Model: S-P2	Date: 16-Oct-08	No.: RM001001a
-------------	-----------------	----------------

Subject: Firmware Release Note: Network DocBox		Prepared by: Y.Murata	
From: 1st Tech. Support Sec. Service Support Dept.			
Classification:	<input type="checkbox"/> Troubleshooting <input type="checkbox"/> Mechanical <input type="checkbox"/> Paper path <input checked="" type="checkbox"/> Other ()	<input type="checkbox"/> Part information <input type="checkbox"/> Electrical <input type="checkbox"/> Transmit/receive	<input type="checkbox"/> Action required <input type="checkbox"/> Service manual revision <input type="checkbox"/> Retrofit information

This RTB has been issued to announce the firmware release information for the **Network DocBox**.

Old P/N	New P/N	Description	Q'ty	Int	Page	Index	Note
-	G1751566	DOOR:FRONT	1	-	5	24	-

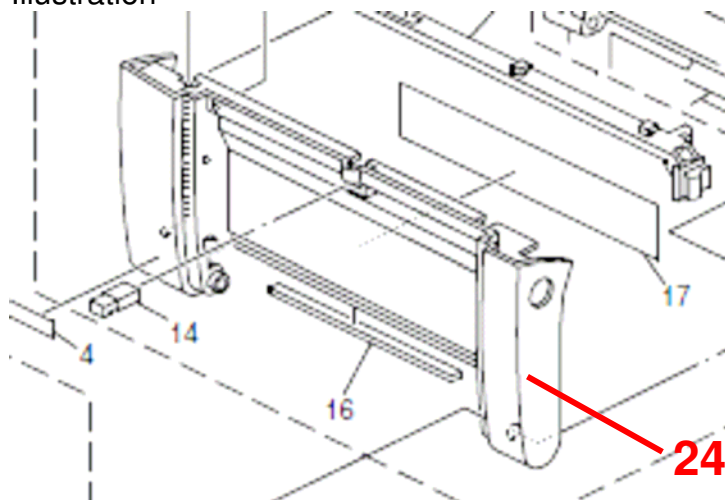
Change/Reason: Newly added the following parts.
